SECTION 4.55

LEVEL 5 - PHASE A

RPAC
26 ALBION STREET WAVERLEY NSW 2024

DRAWING No. **4.55(1A)104** REV **A**

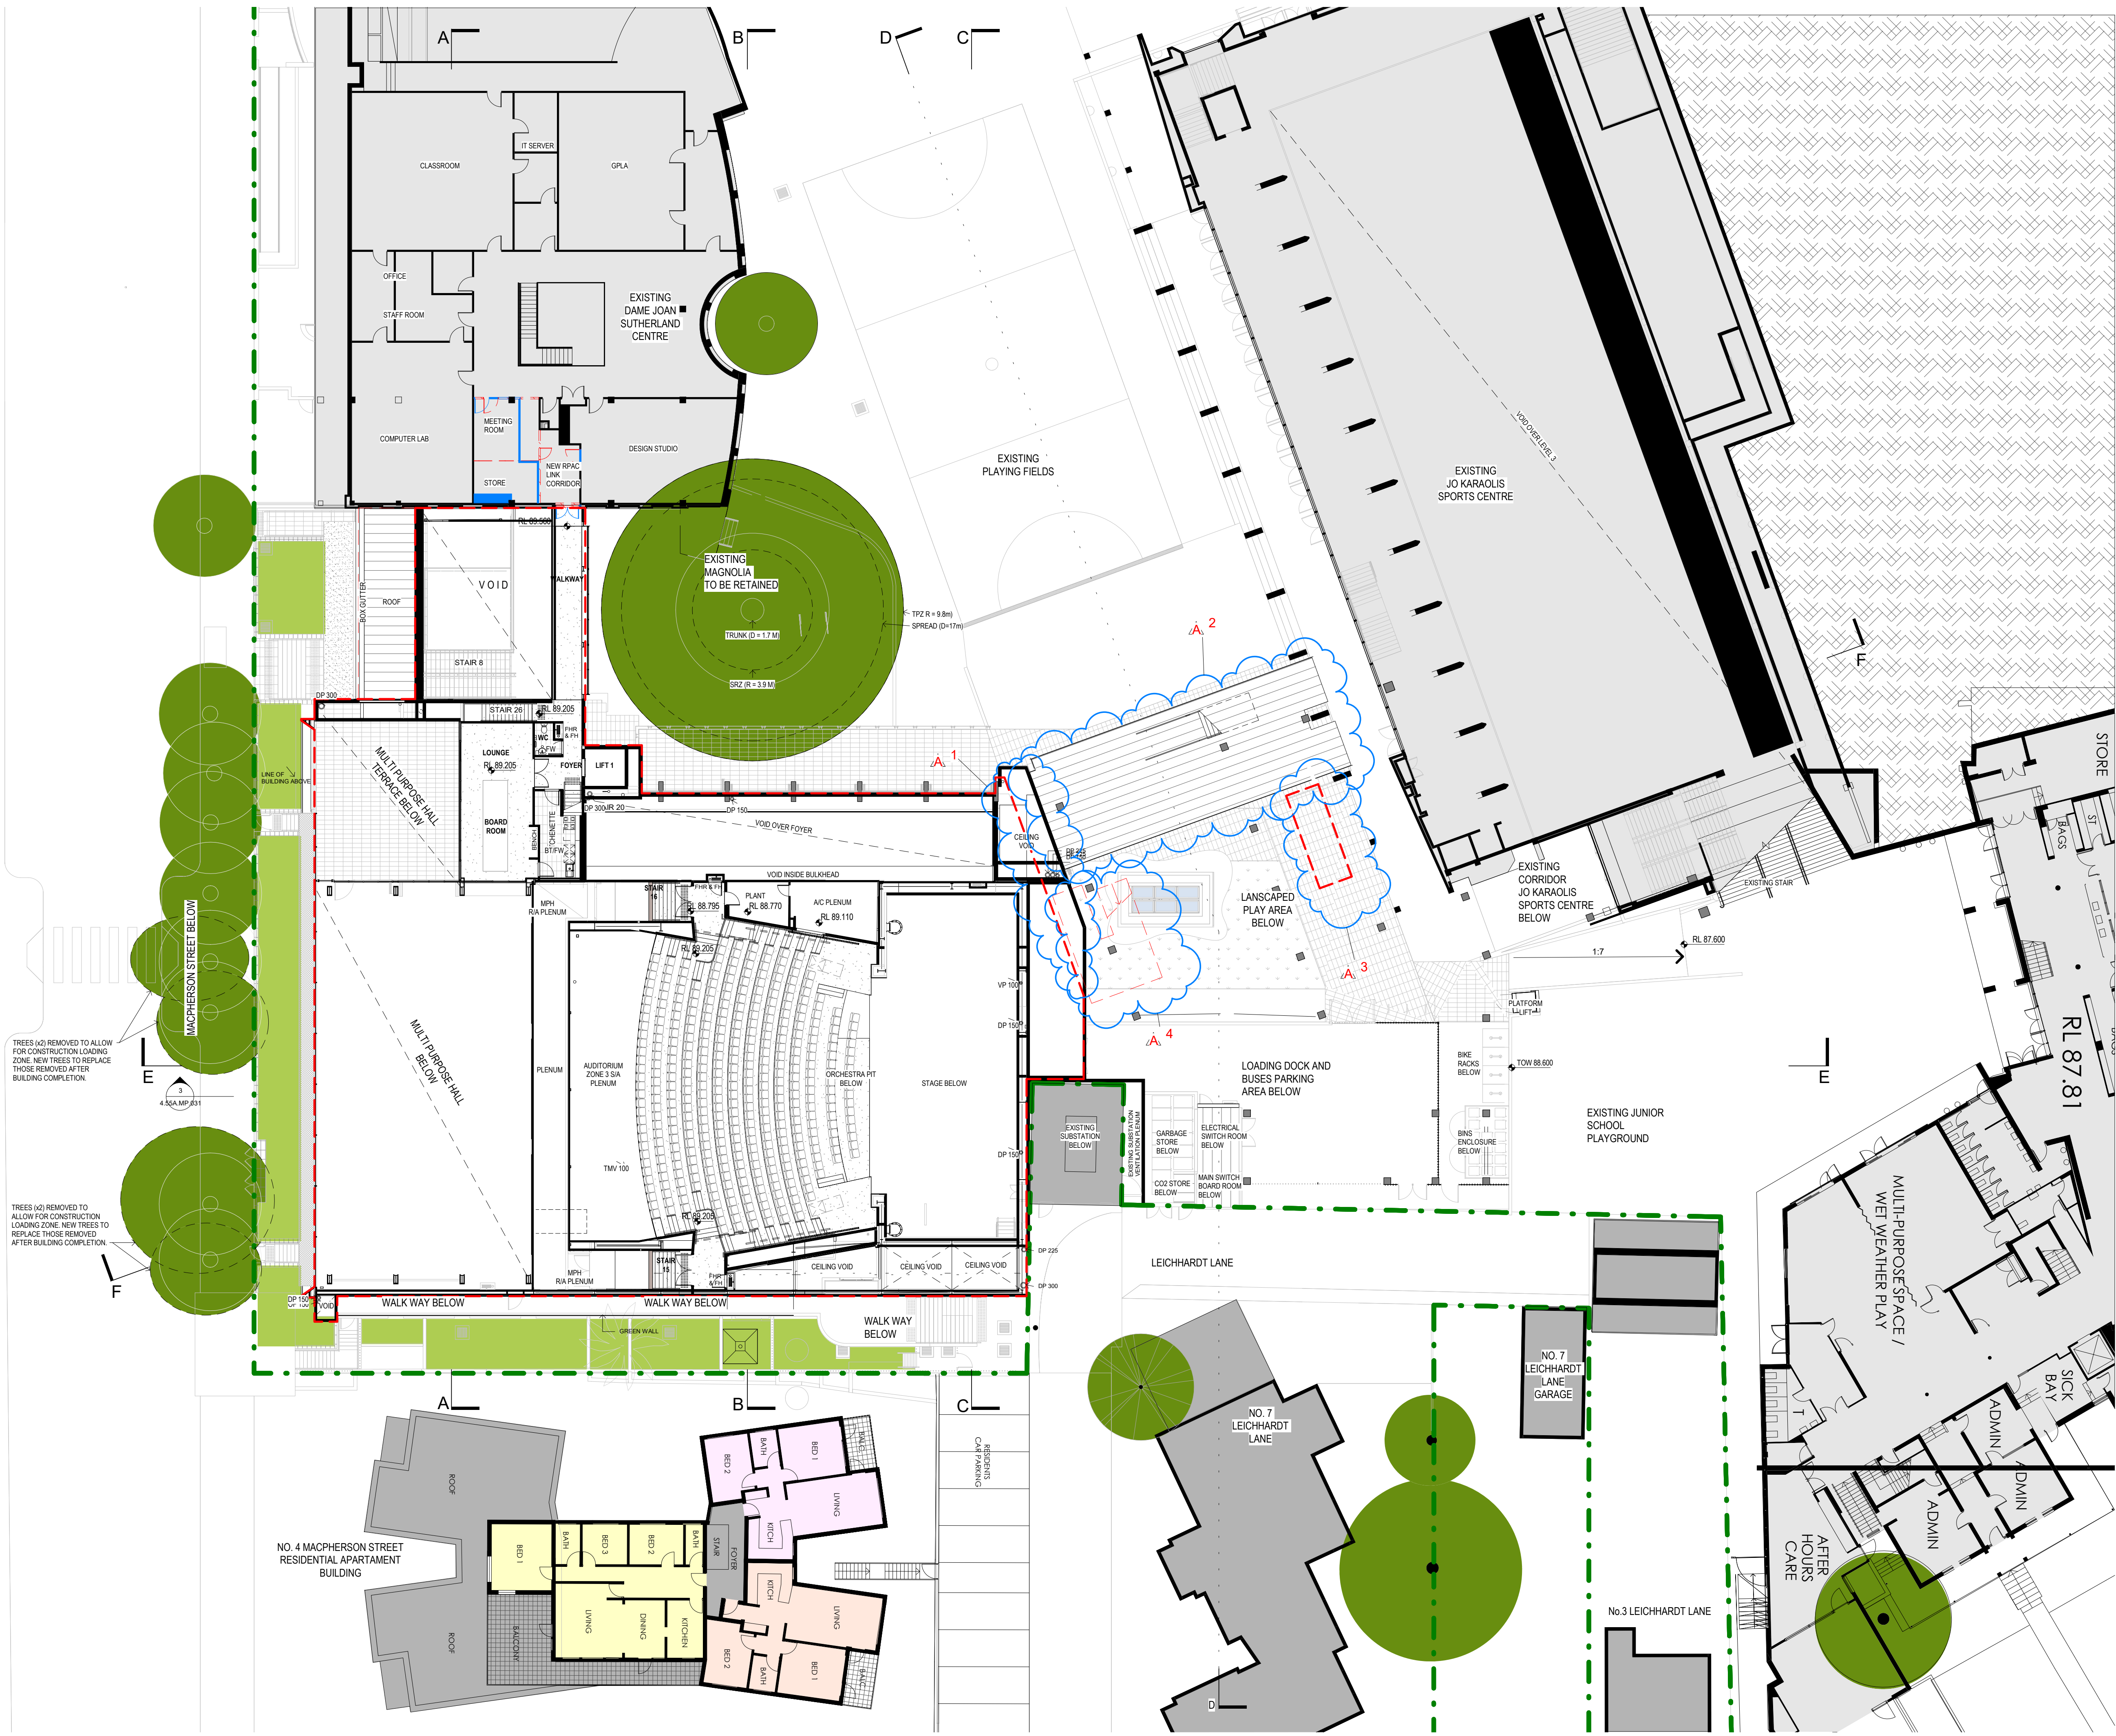
- LIST OF CHANGES LEVEL 5:
1. SIZE OF SERVICES RISER AND CEILING VOID INCREASED.
 2. TEMPORARY ROOF STRUCTURE FOR WET WEATHER LINK BETWEEN RPAC (PHASE A) AND JO KARAOULIS SPORTS CENTRE. TO BE DEMOLISHED AT COMMENCEMENT OF PHASE B
 3. STAIR 12 LOCATION AND ORIENTATION AMENDED.
 4. EXTERNAL STAIR TO RESEARCH CENTRE RELOCATED.

DRAWING No. 4.55(1B)104 REV A

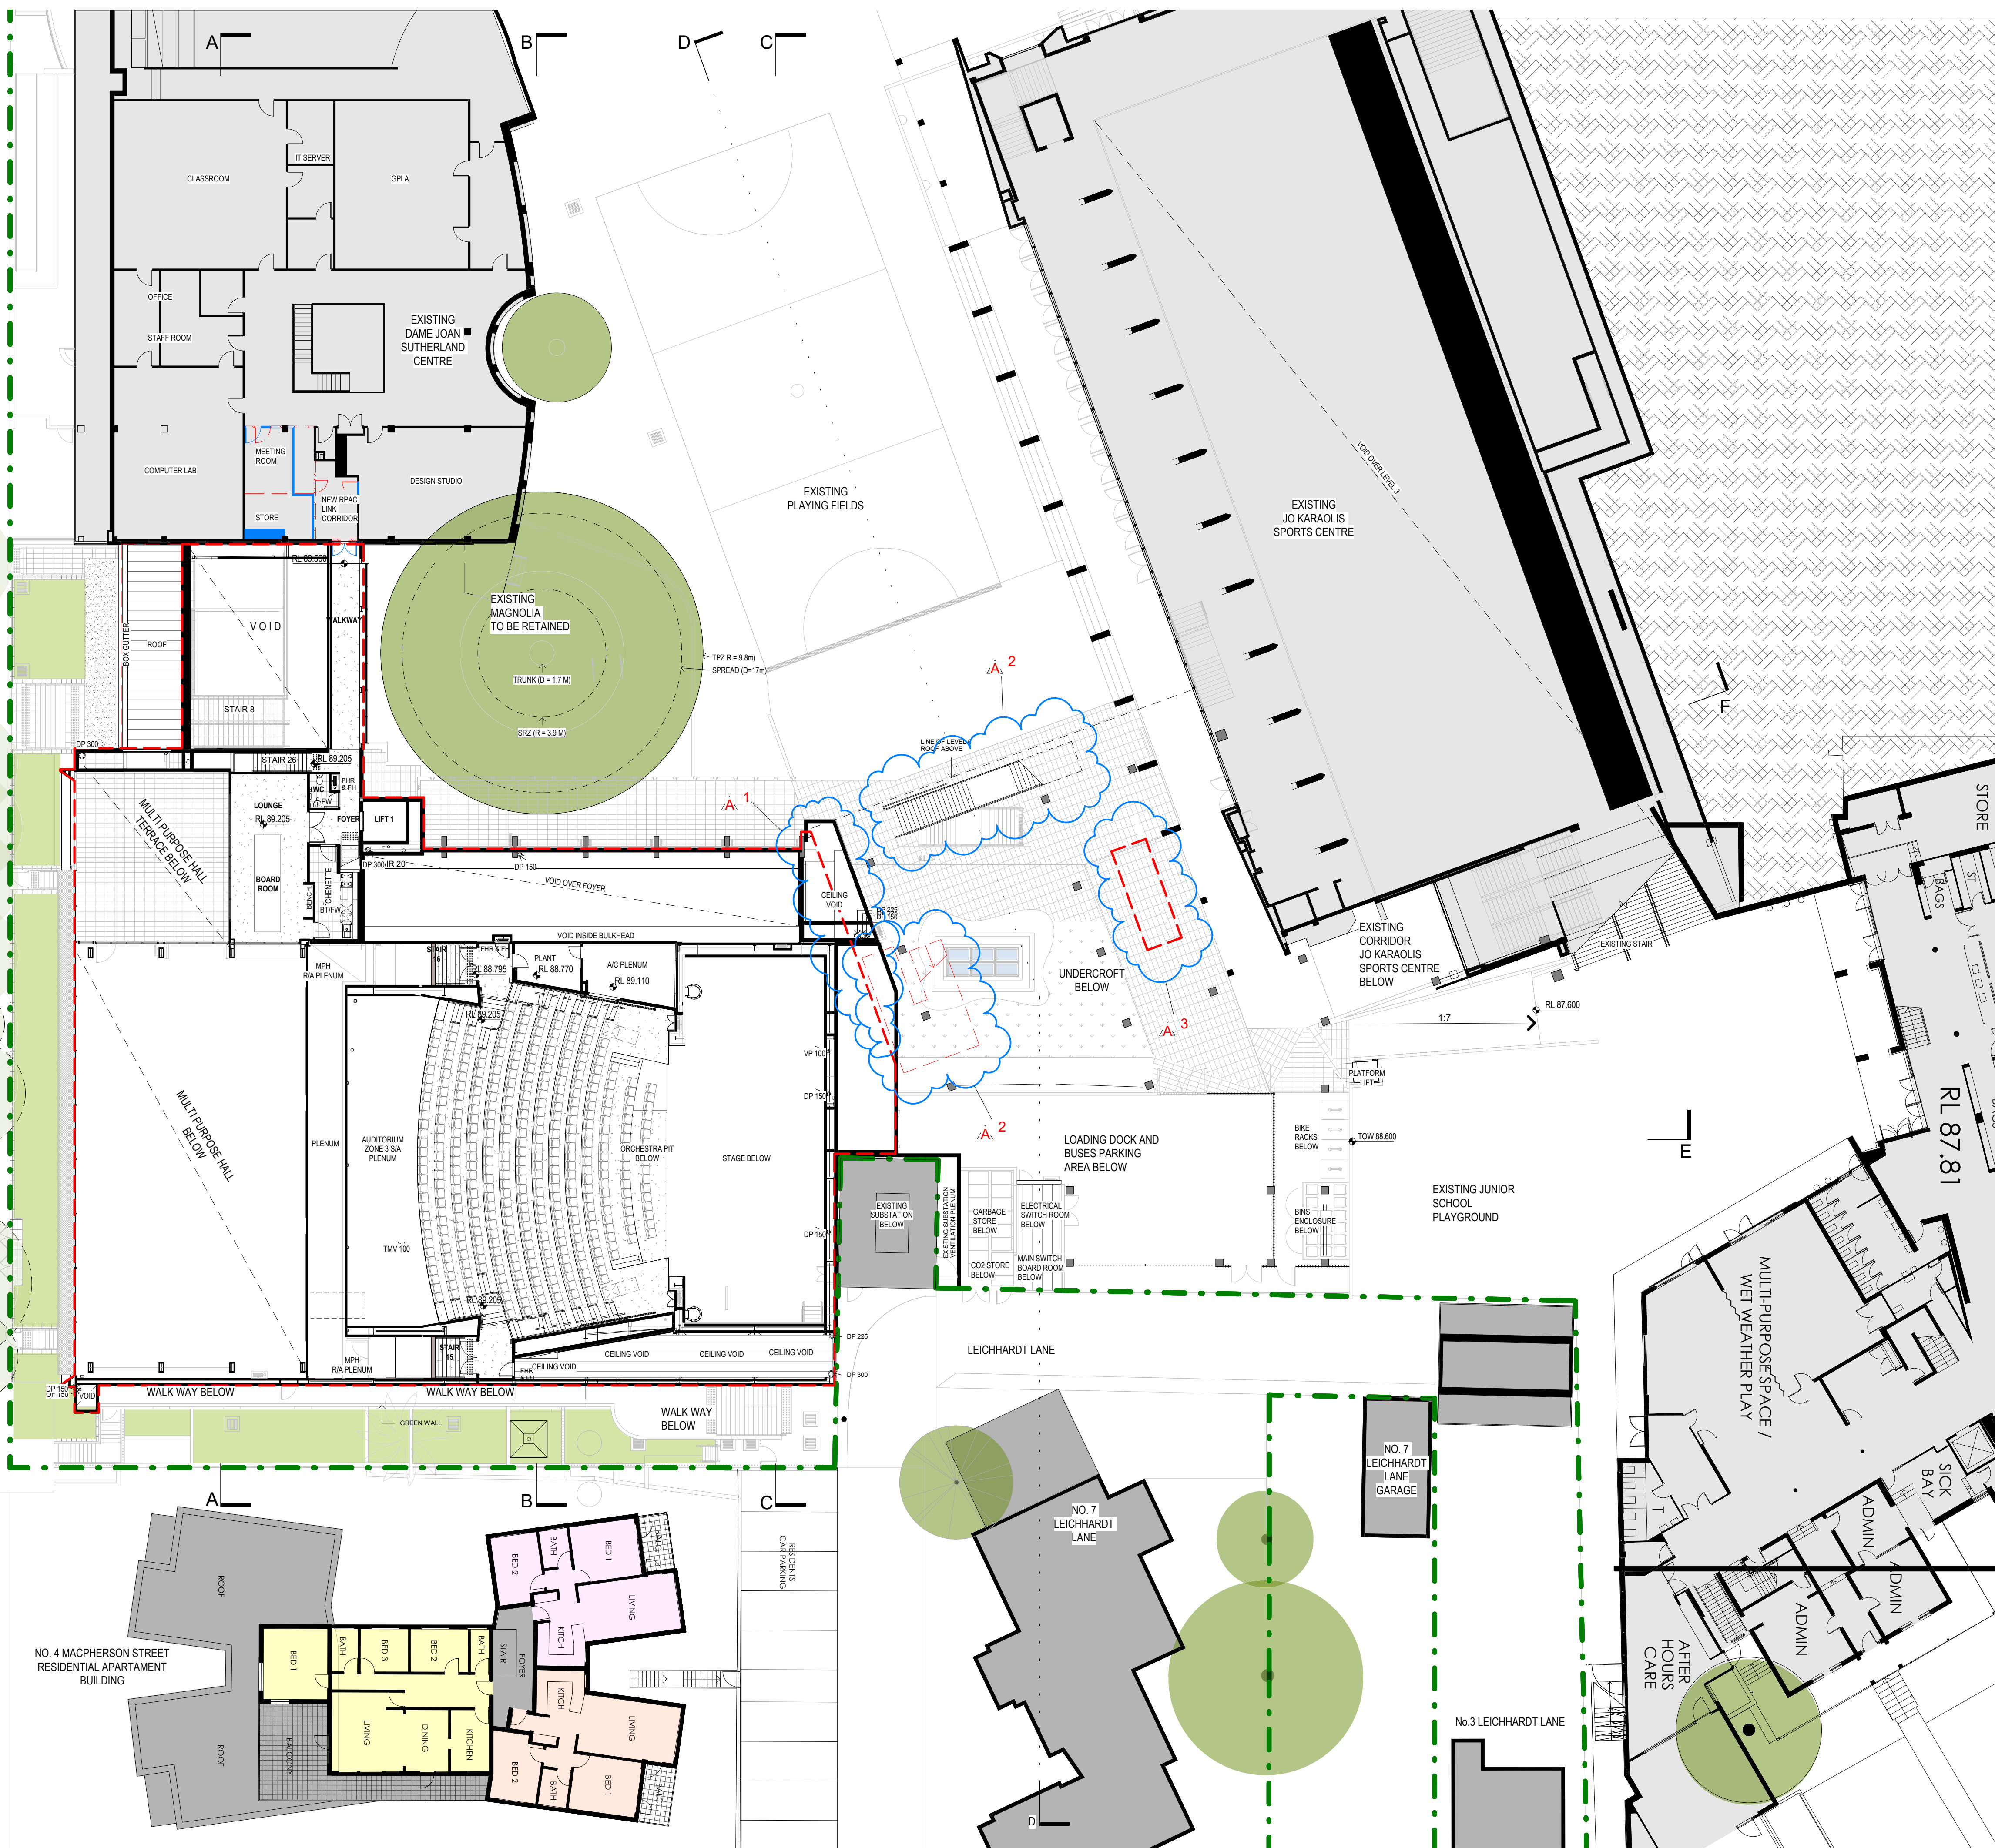
LIST OF CHANGES LEVEL 5:

1. SIZE OF SERVICES RISER AND CEILING VOID INCREASED.
2. EXTERNAL STAIR TO RESEARCH CENTRE RELOCATED.
3. STAIR 12 LOCATION AND ORIENTATION AMENDED.
